**Re: ADDENDUM TO DRAFT FINAL SAMPLING AND ANALYSIS PLAN
ADDITIONAL GROUNDWATER INVESTIGATION AT TIDAL AREAL
LANDFILL, SITE 1, NAVAL WEAPONS STATION SEAL BEACH,
DETACHMENT CONCORD, CONCORD, CALIFORNIA**

**Addendum to
Sampling and Analysis Plan
(Field Sampling Plan/Quality Assurance Project Plan)
Additional Groundwater Investigation at
Tidal Area Landfill, Site 1**

ADDENDUM 01

RESPONSES TO AGENCY COMMENTS
DRAFT FINAL SAMPLING AND ANALYSIS PLAN
ADDITIONAL GROUNDWATER INVESTIGATION AT TIDAL AREA LANDFILL
NAVAL WEAPONS STATION SEAL BEACH, DETACHMENT CONCORD
CONCORD, CALIFORNIA (DATED 21 DECEMBER 2004)
March 31, 2005

FIGURE 7
PROPOSED LOCATIONS FOR TIDAL INFLUENCE STUDY
Tidal Area Landfill
Additional Groundwater Investigation
SAP Addendum

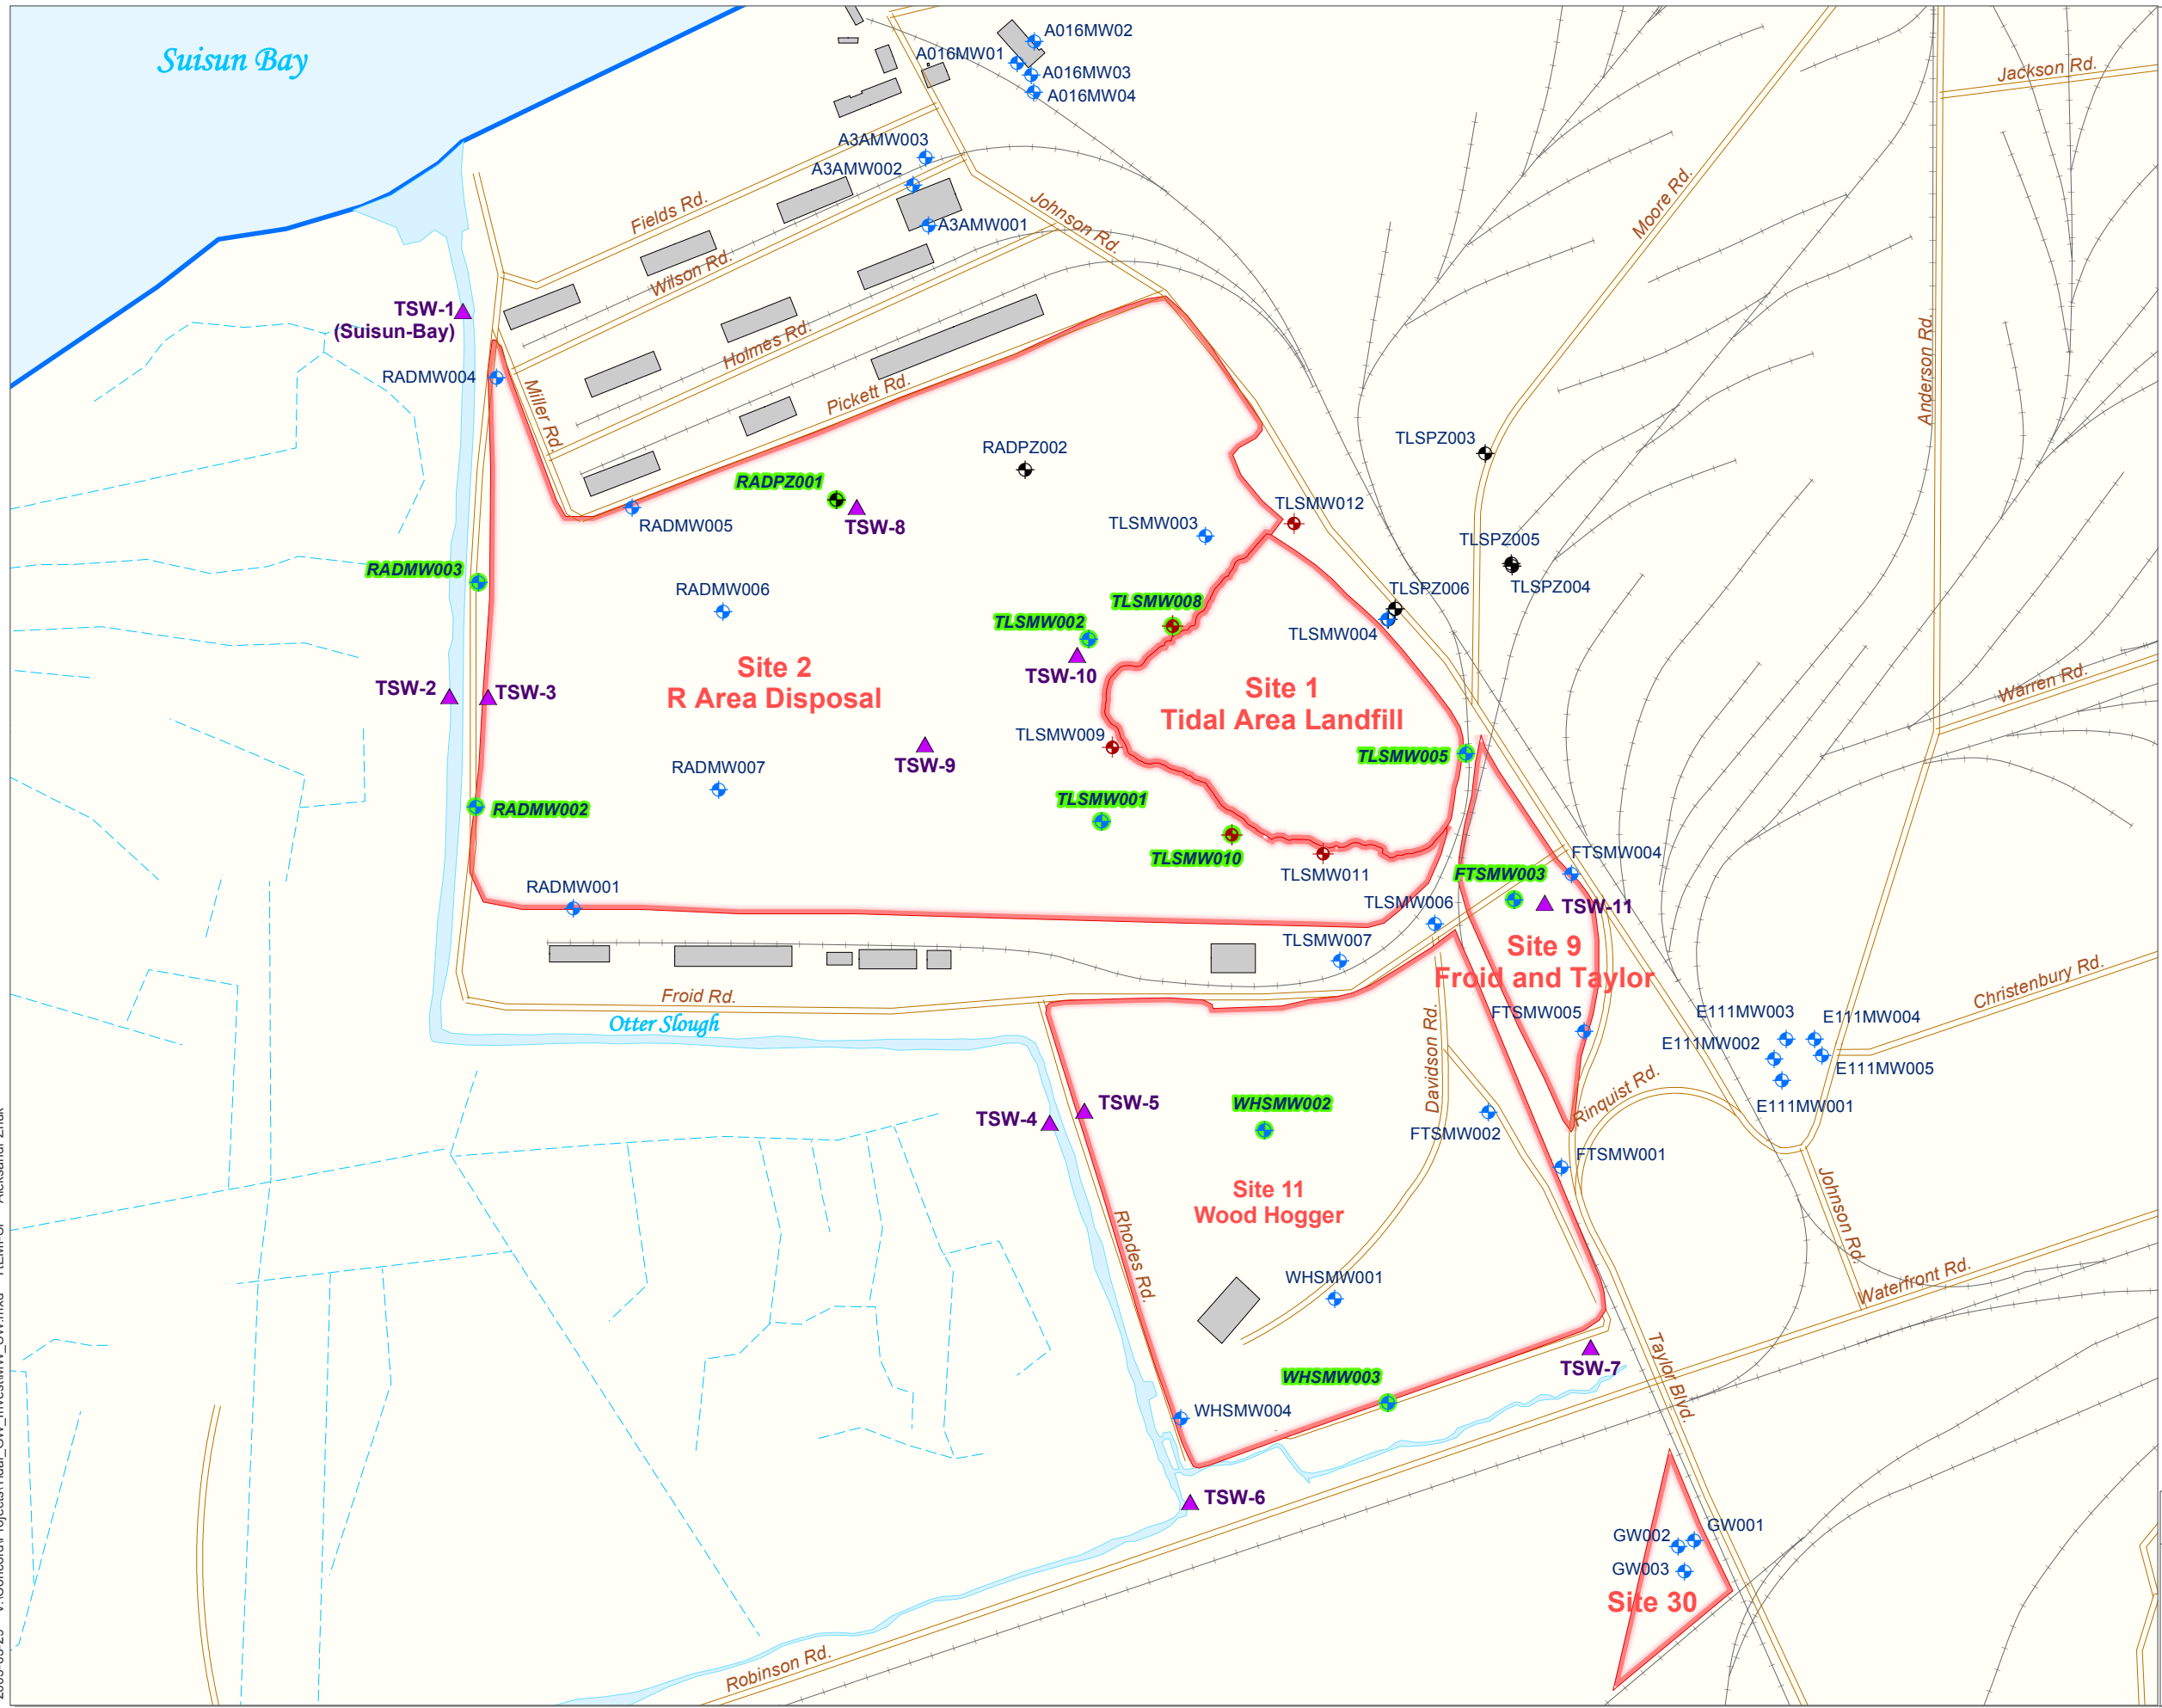
As requested by the U.S. Environmental Protection Agency (EPA) the Navy will include well TLSMW005 in the tidal influence study in place of well RADMW005. TLSMW005 is located on the east side of the landfill and no other well is being measured for tidal influence near that location. RADMW005 is located in Site 2 and there are several other wells that are already proposed for tidal influence study in Site 2. [Table 8](#) and [Figure 7](#) indicate the revised monitoring locations for the tidal influence study proposed.

Page 32 and Figure 7. Please add the following locations to the tidal influence study:

e. Move groundwater monitoring location TLSMWOIO to TLSMWOI 1
f. Please add tidal surface water and groundwater survey locations at TLSMW004.

Figure 7. Please portray the former water channels on this figure.

Figure 7. Several surface water sample locations (e.g., TSW-3, TSW-5, TSW-6, and TSW-8 to TSW-11) are located in areas away from Otter Slough. Will surface water be present during the dry season sampling in these areas?

Response: The former water channels in the vicinity of the Tidal Area Landfill are best presented on a larger-scale map, such as Figure 2. Please refer to that figure for locations of the water channels.

Response: Much of Site 2 now floods regularly, even in the summertime. Although the depth or presence of water at specific locations will not be known until measurements are taken, at least some of these locations are expected to be flooded with surface water.

Response: All locations identified “TSW” (TSW-1 through TSW-11) are surface water monitoring locations and shown with a triangle symbol (see [Figure 7](#)). All other locations are groundwater monitoring locations.
